Amendment C231 – Queens Parade Built Form Review

15-33 Queens Parade, Clifton Hill

Expert Urban Design Evidence

August 2019

Figure 8 - Council 3D modelling with DLA emphasis on the Site and one additional level setback 1m from the edge of the floor below, above the preferred height indicatively shown

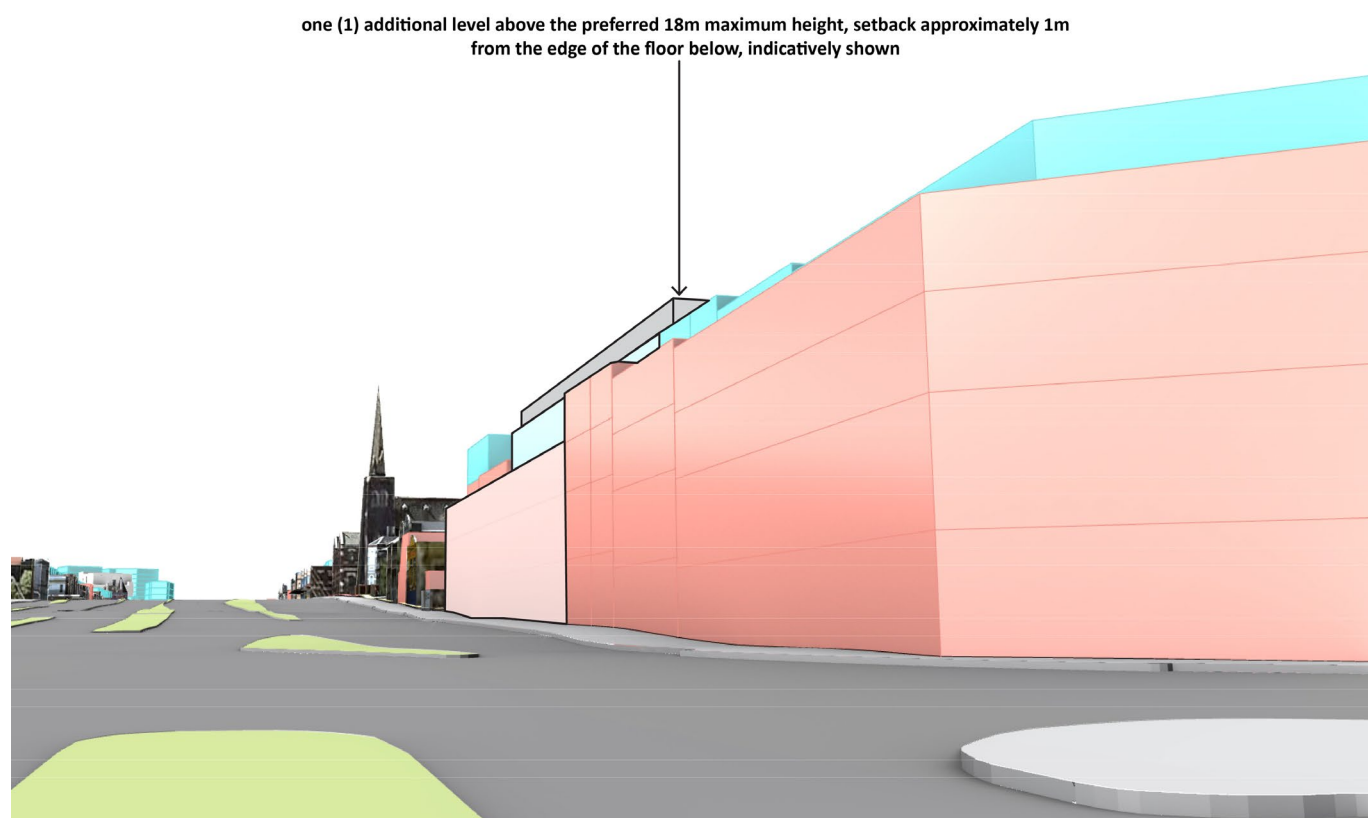
- [43] The 3D modelling below provided by Yarra City Council applies the street wall height, building height and setbacks proposed in Precinct 3A of DDO16. An 6th storey has been added to the 3D view to test its impact.

- [44] Due to the nature of the site and its size, the diagram demonstrates that a height greater than 5 storeys can be achieved whilst responding to heritage, character and ensuring the primacy of St John's Church as a landmark is maintained. Refer to Figure 8.

^[45] For the reasons above, I support a preferred building height of 5 storeys as stated in the exhibited DDO16.

Figure 14 - Extract from post-exhibition DDO16 of the suggested rear setback treatment

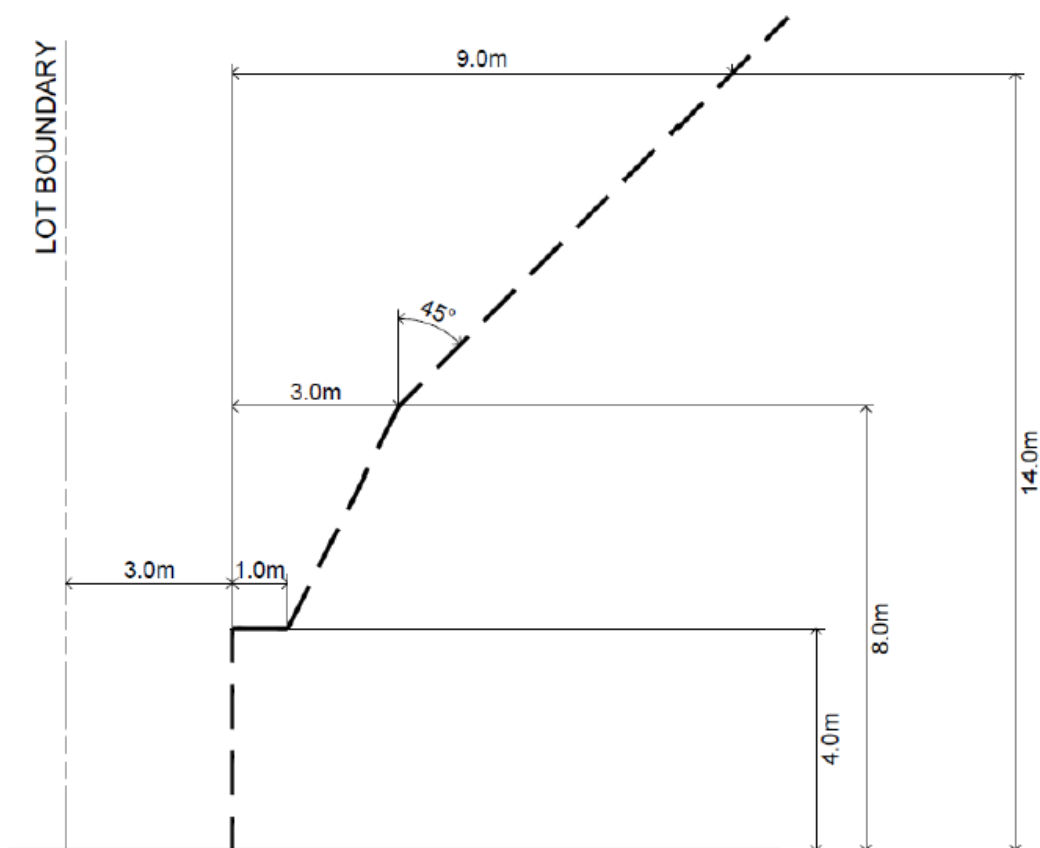
[72] I note that there is no laneway to the rear of the Site and therefore “Figure 2” is applicable, as extracted below:

Figure 15 - North-South section through cutting through the Site and 20 Hodgkinson Street testing the extent of built form

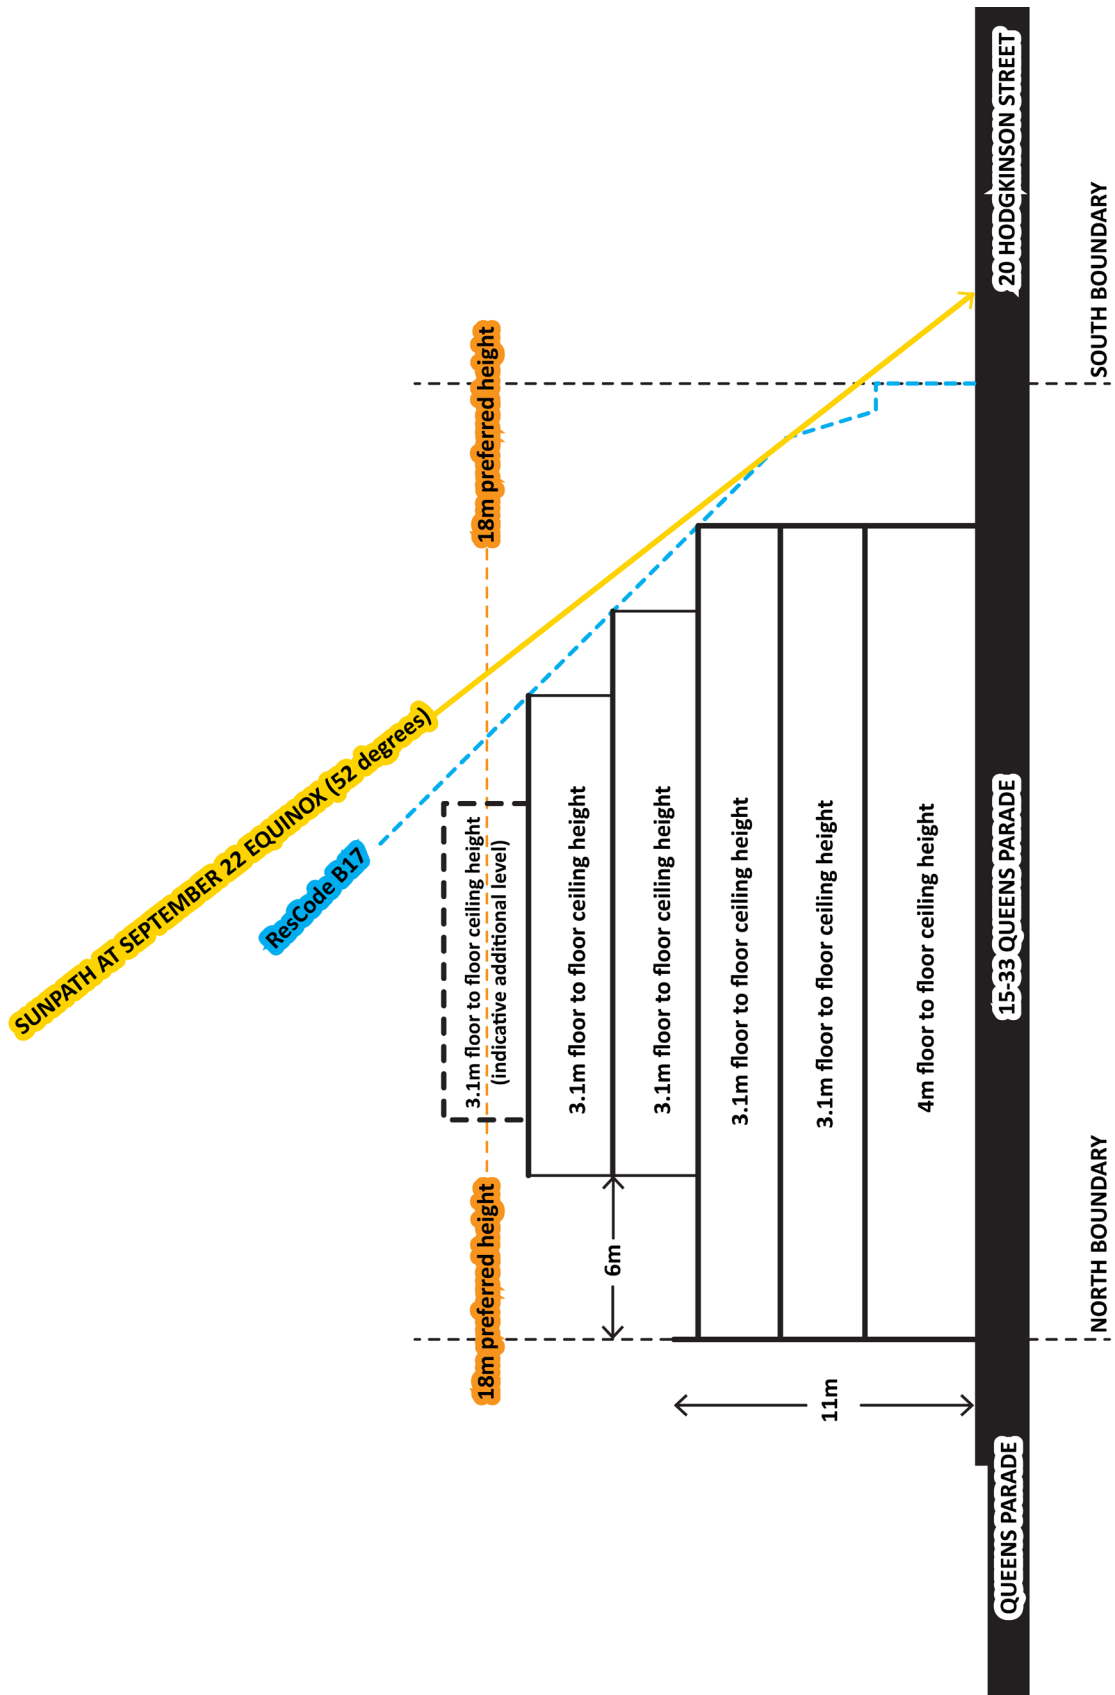
[73] In relation to the post-exhibition DDO16, I generally support the introduction of the requirement to respond to the low scale form of the existing development outside Precinct 3 on Hodgkinson Street. I find the introduction of a discretionary Rescode Standard B17 an appropriate control to manage off-site amenity. Although I note the diagram above includes a 3m setback from the lot boundary. This would be more onerous than Standard B17 of Clause 55 and should be deleted. Refer to Figure 15.
